May 27, 1980

Docket No. 50-348  
No. 50-364

Re.: Letter from Mr. A. Schwencer to  
Mr. F. L. Clayton Dated April 8, 1980,  
Concerning Auxiliary Feedwater

Enclosure 1

FIGURE 1

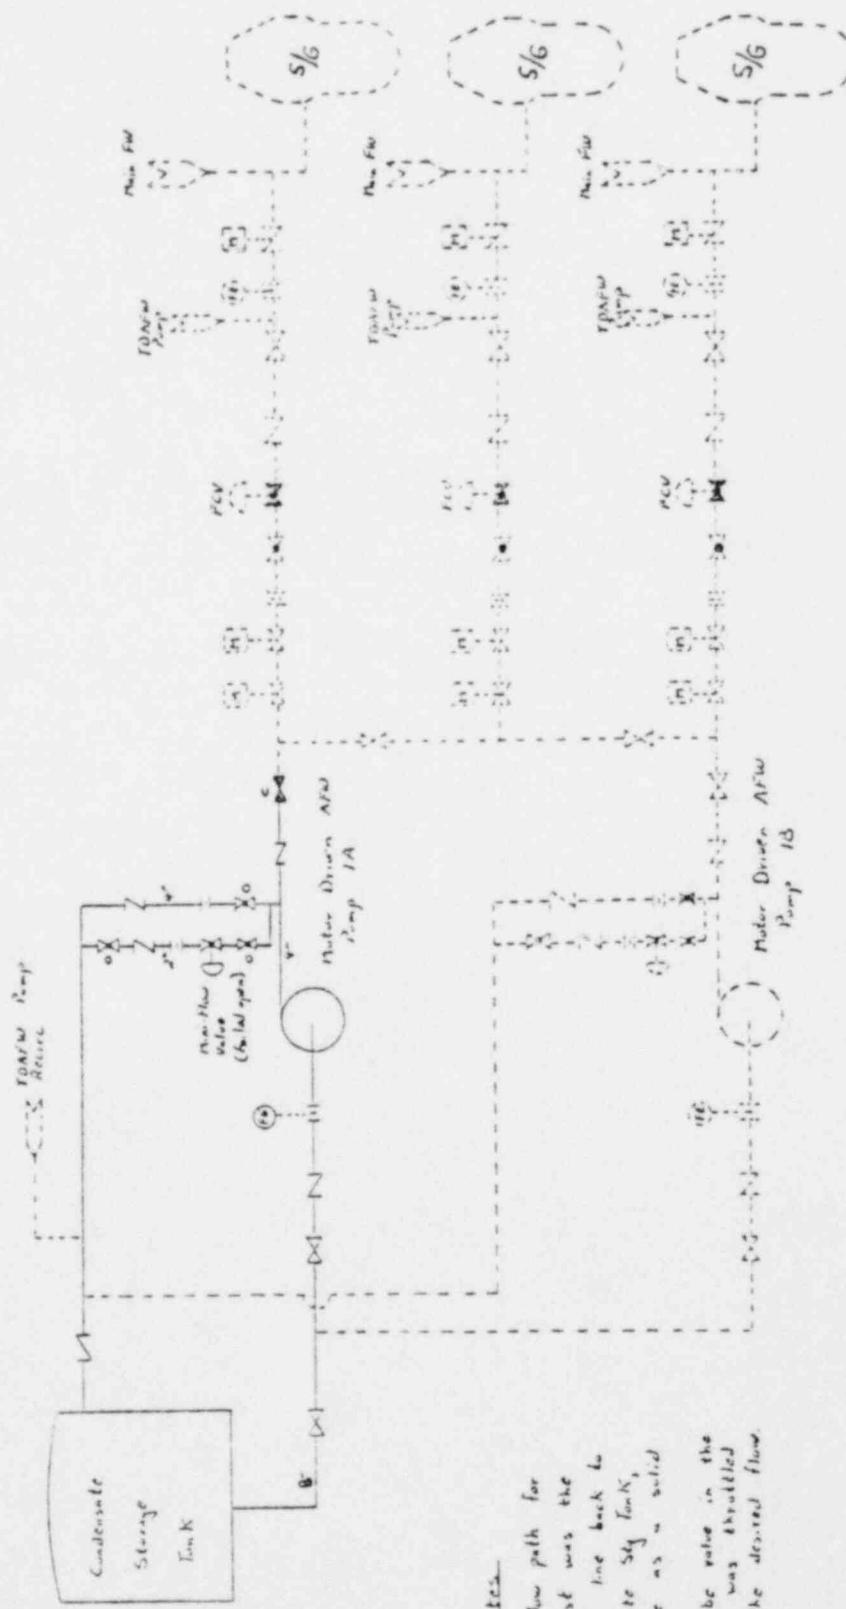
A brief description of the test method (including flow schematic diagram) and how the test was instrumented (i.e., where and how the bearing temperatures were measured).

There were two alternate test modes possible for each pump, i.e., recirculation back to the condensate storage tank or feeding the steam generators (see Figures 1, 2 and 3). The recirculation path to the condensate storage tank from each pump includes a full flow test line as well as a smaller minimum flow line. Ingersoll-Rand recommends that the pumps not be operated for an extended period of time in any mode that would not allow at least 25% of rated flow. The minimum flow lines do not meet this criteria, therefore, the full flow test line was utilized in the 48-hour endurance test. For the purposes of these tests, Motor Driven AFW Pump 1A utilized the recirculation path to the condensate storage tank while tests for Motor Driven AFW Pump 1B and the turbine driven AFW Pump utilized flow to the steam generators.

FIGURE 5

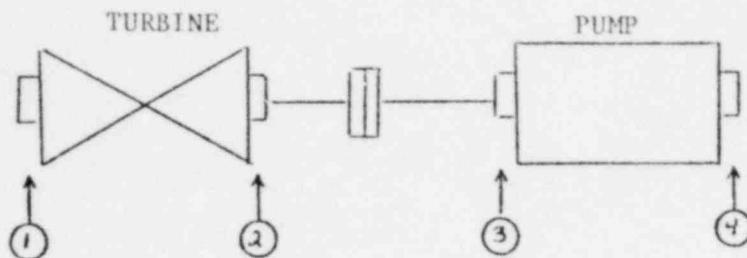
Plots of bearing/bearing oil temperature vs. time for each bearing of each AFW pump/driver demonstrating that temperature design limits were not exceeded.

For the turbine driven pump, the bearing oil temperature increased steadily for the first two hours of operation, then leveled off between 181°F.-183°F. for the remainder of the test. (See Figure 5 for TDAFW pump bearing/bearing oil temperature measurement and Figure 14 for a plot of all temperatures.)

FIGURE 7

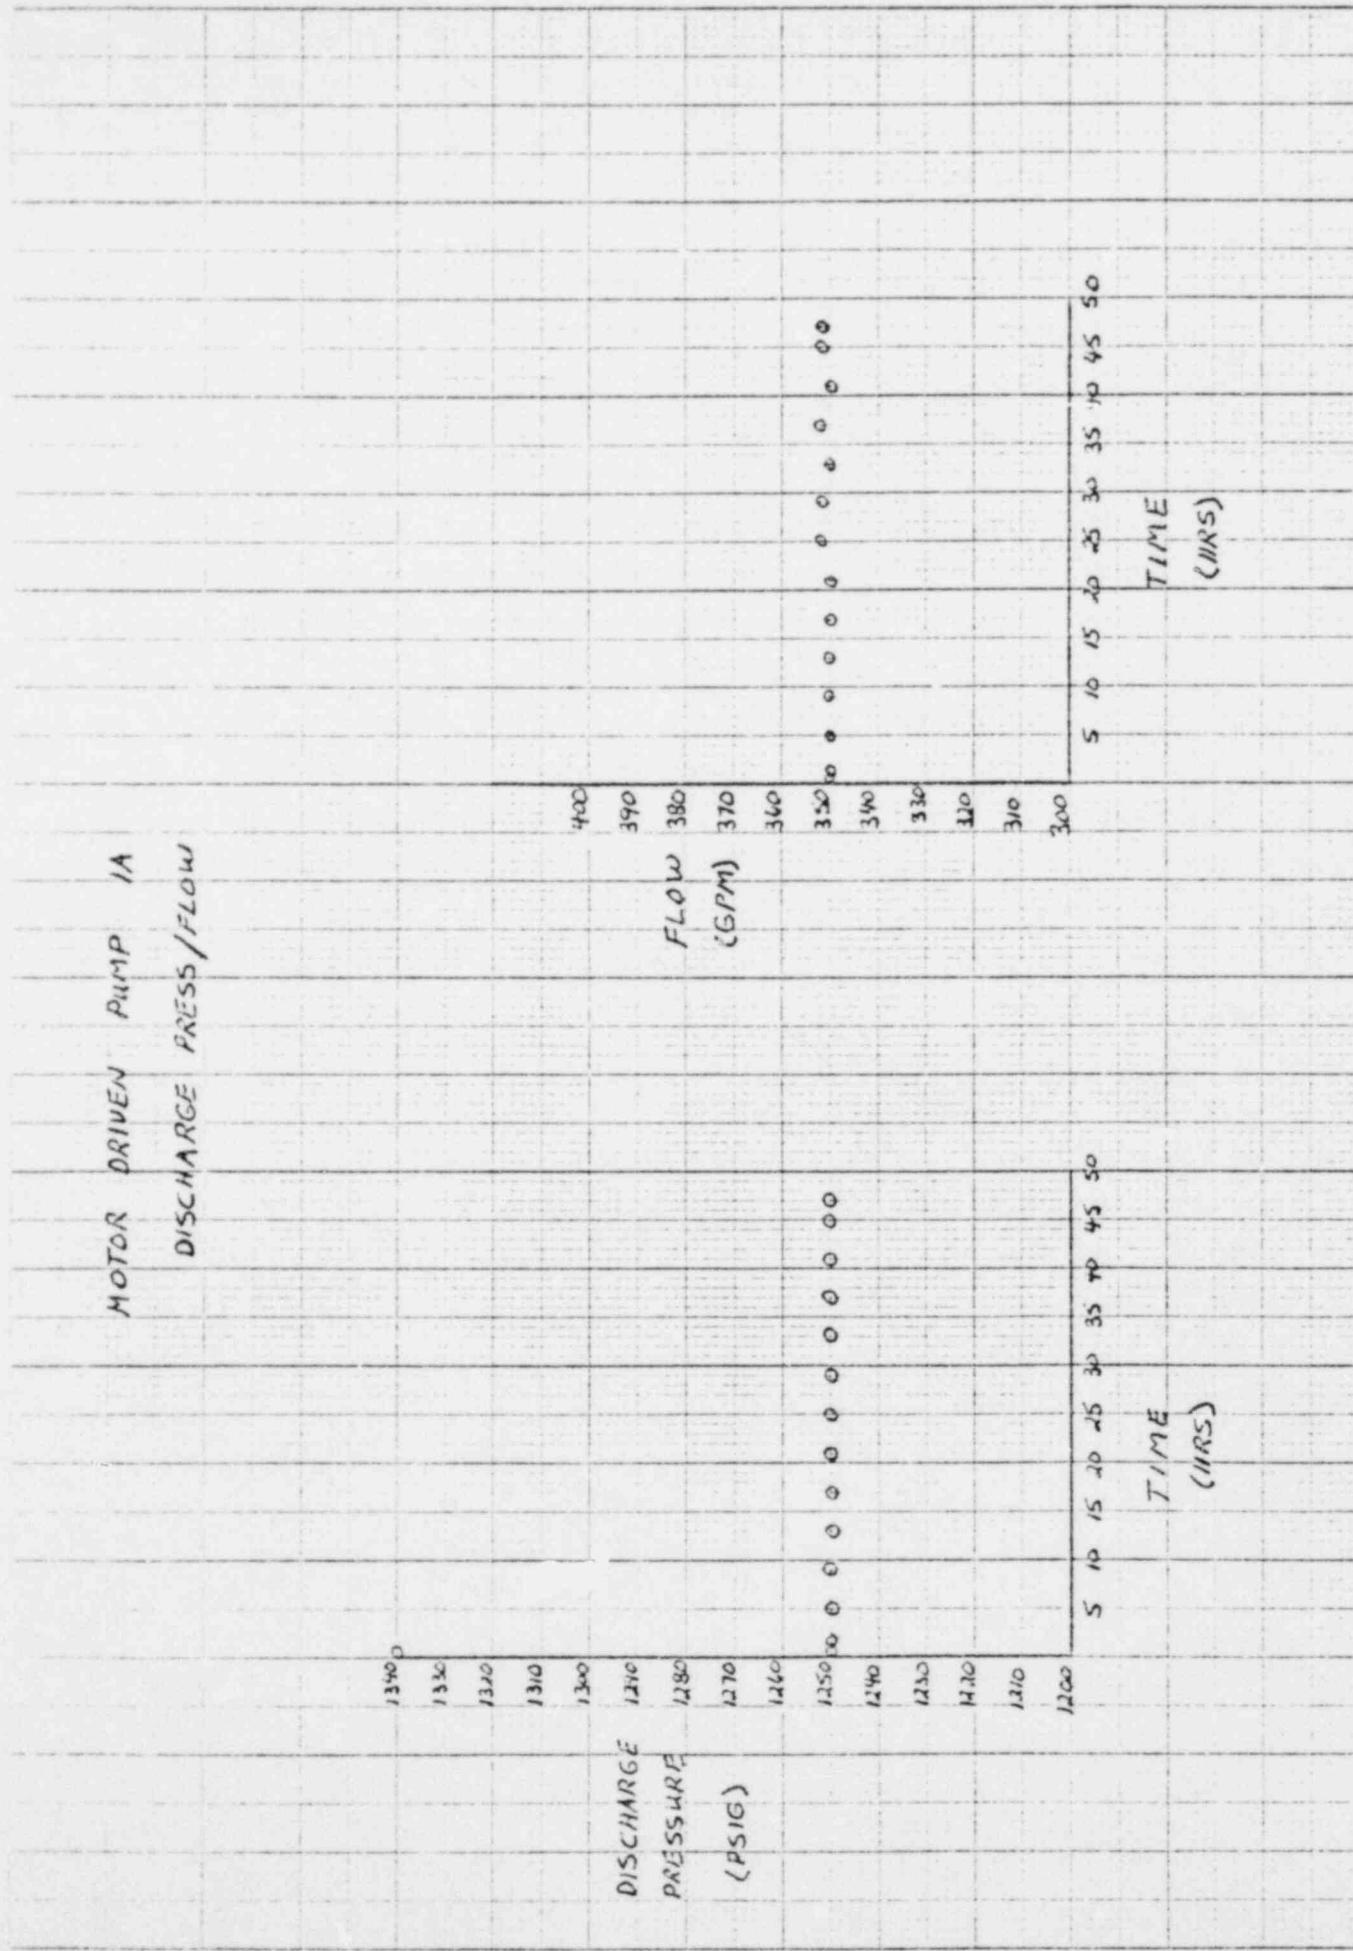
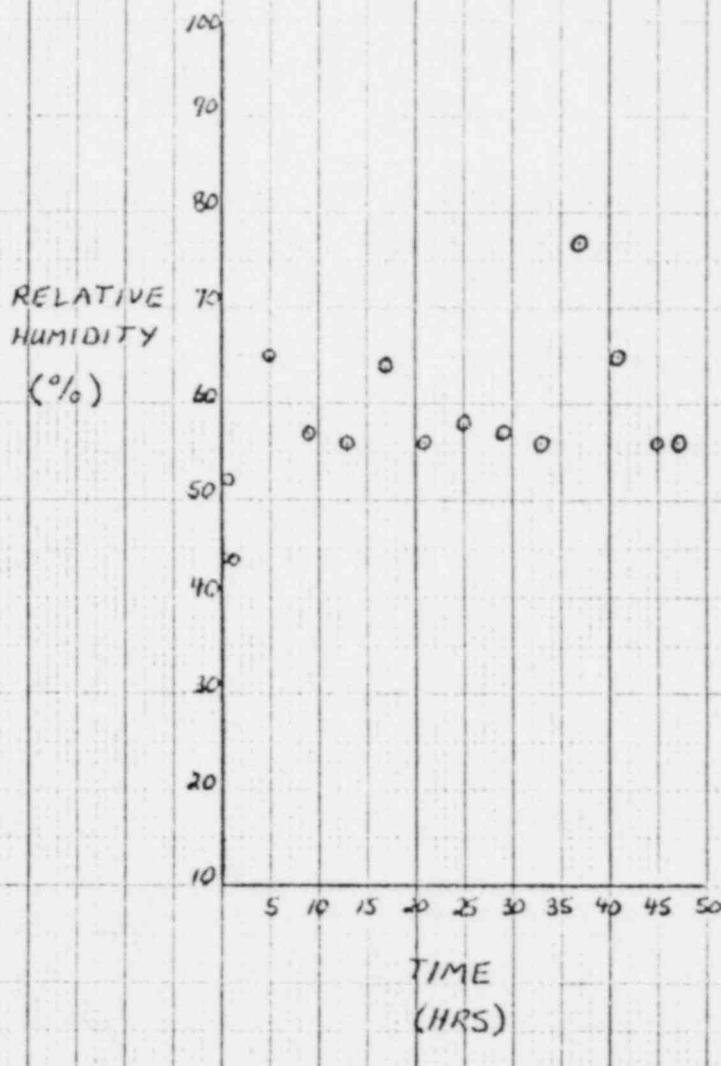
A discussion of how the test conditions (pump flow, head, speed and steam temperatures) compare to design operating conditions.

The pressure and flow for motor driven pumps 1A and 1B and the turbine driven pump are shown in Figures 7, 11 and 15 respectively. All readings are within the manufacturer's operating limits. The variation of pressure and flow with time on the TDAFW pump is attributable to drift of the flow control valve controllers, the turbine speed controller, or a combination of both. All pumps were operated at rated speed and since the tests on the turbine driven pump were conducted at 90% reactor power, steam temperatures were well above the 400°F. test requirement.

MOTOR DRIVEN PUMP 1A  
ROOM TEMP/HUMIDITY

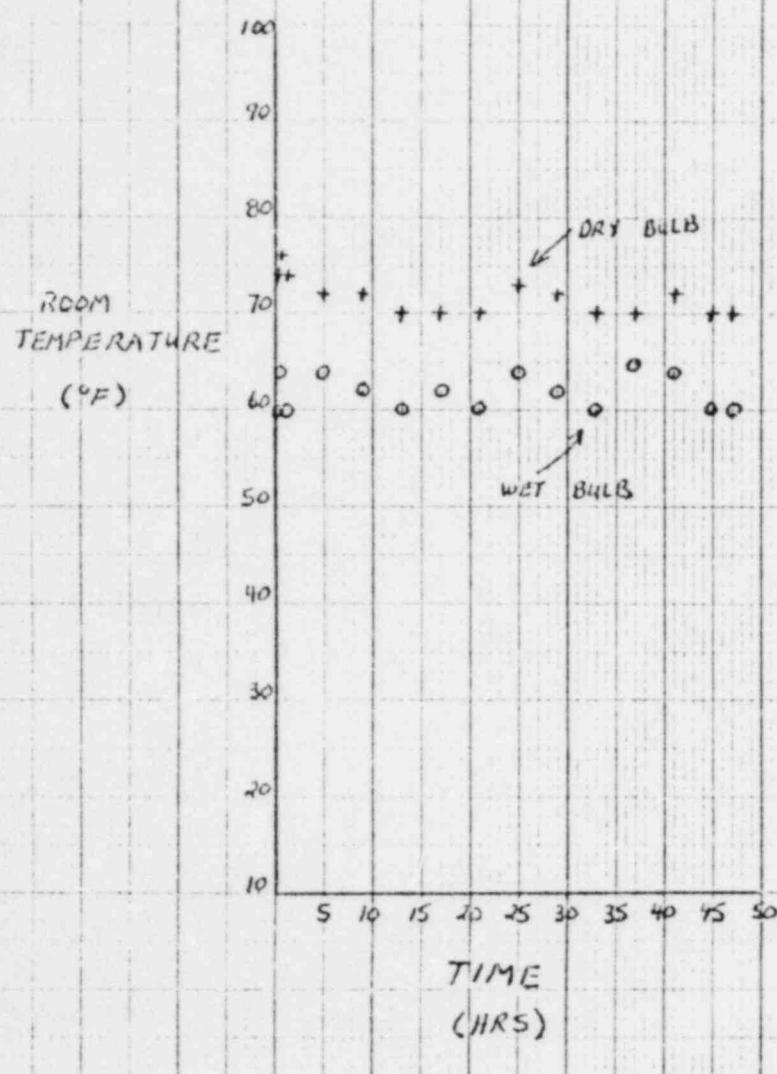
A plot of pump room ambient temperature and humidity vs. time demonstrating that the pump room ambient conditions do not exceed environmental qualification limits for safety-related equipment in the room.

Safety related valves with motor operators located in the pump room include the service water supply isolation valves and the discharge header isolation valves. The motor operators have a nameplate rating of 104° F. and can operate in 100% relative humidity. Safety grade pump room coolers will maintain the maximum room temperature below 104°F. Safety related instrumentation in the pump room was specified for operation at 120°F. and 100% relative humidity. Figures 8, 12, and 16 demonstrate that none of these values were exceeded for the two motor driven and the turbine driven pumps respectively.

FIGURE 9

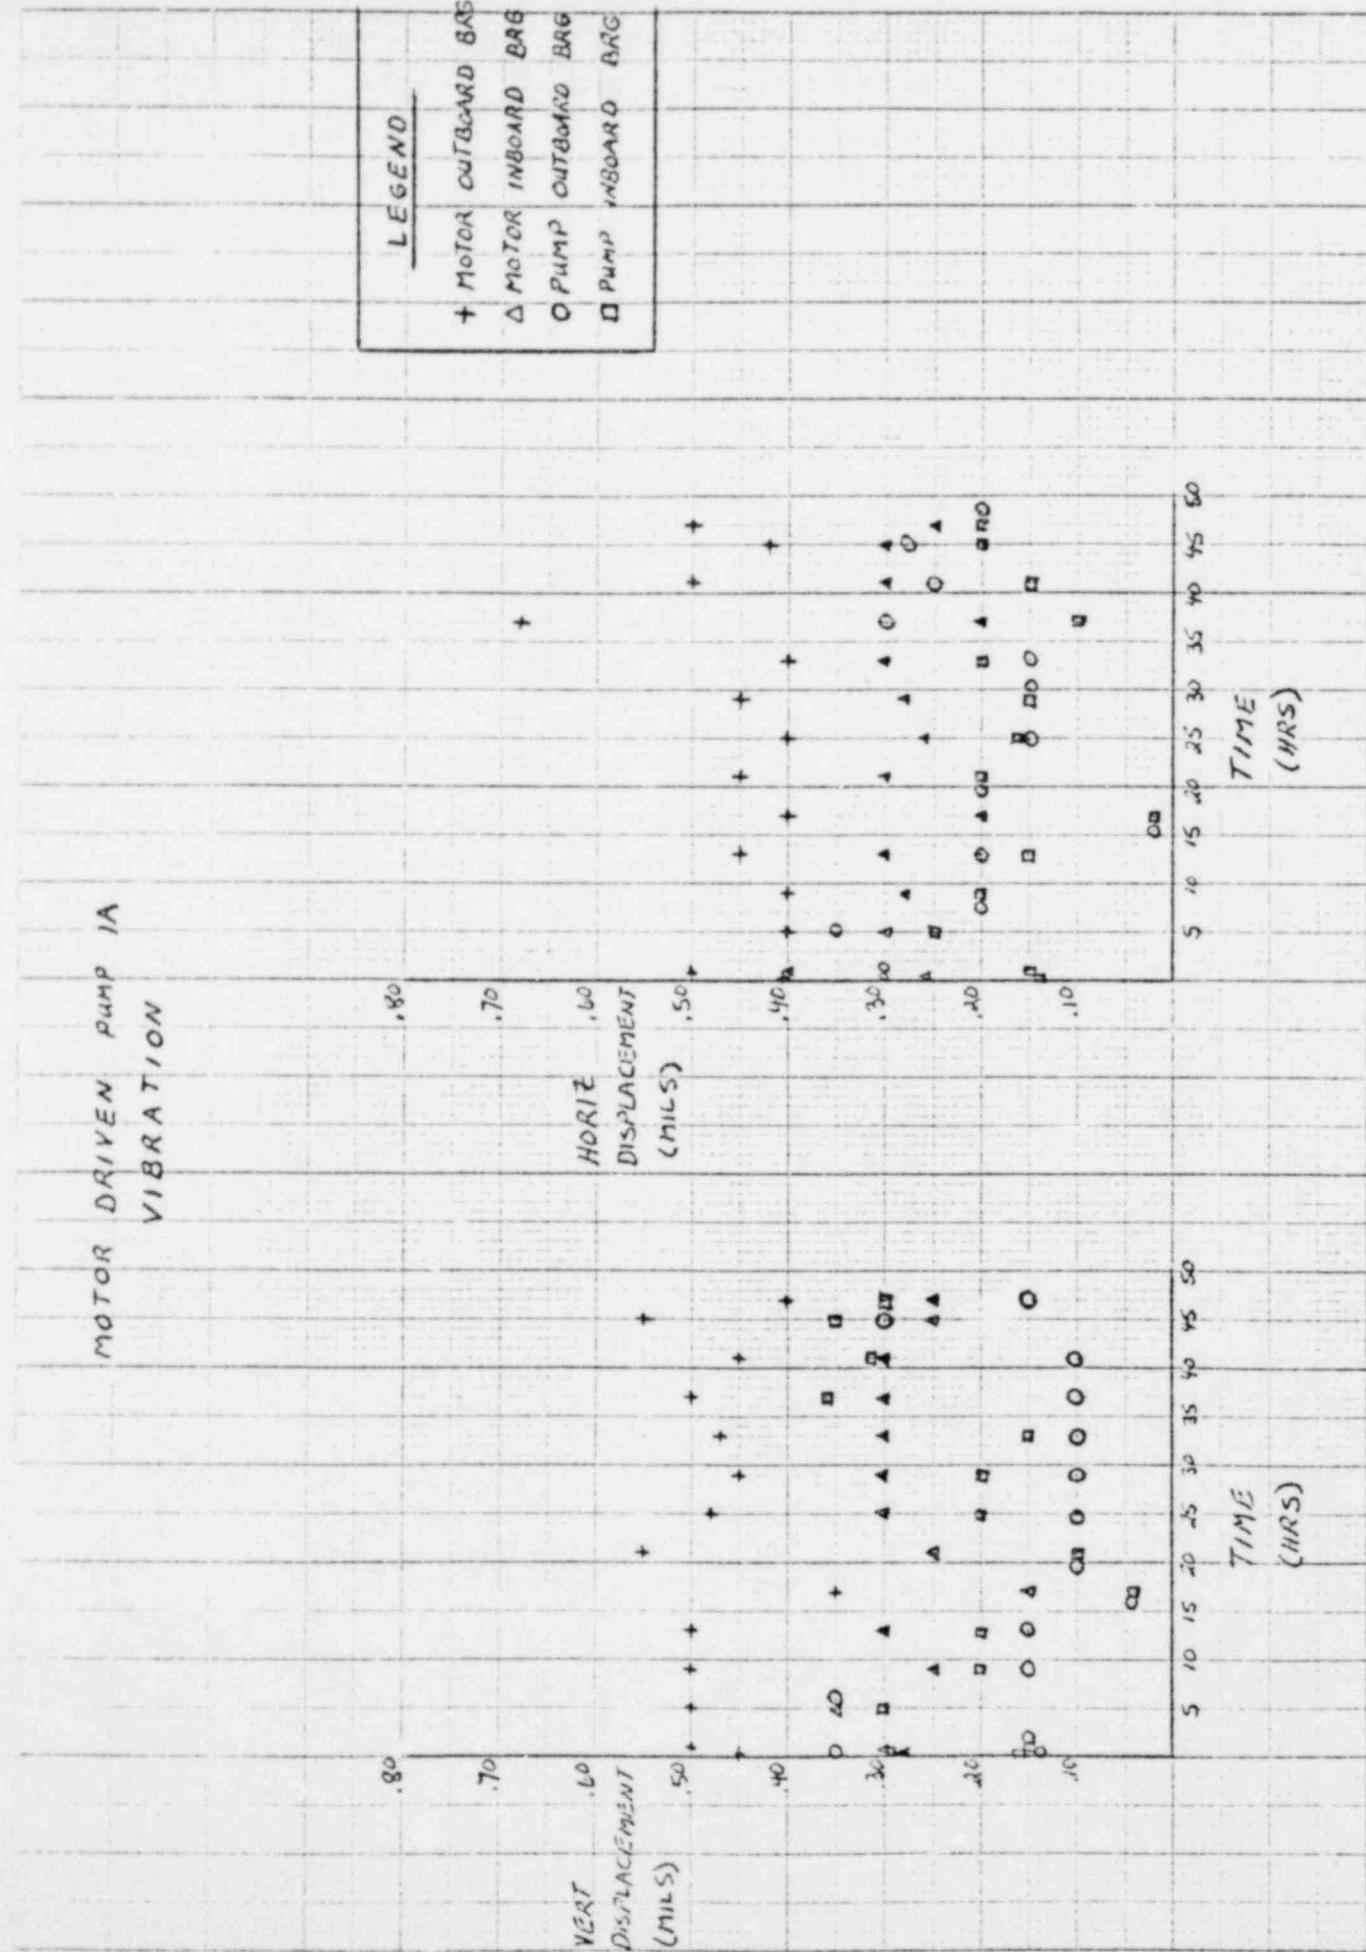
A statement confirming that the pump vibration did not exceed allowable limits during the tests.

Figures 9, 13 and 17 demonstrate that vibration in the motor driven and turbine driven pumps did not exceed allowable limits.
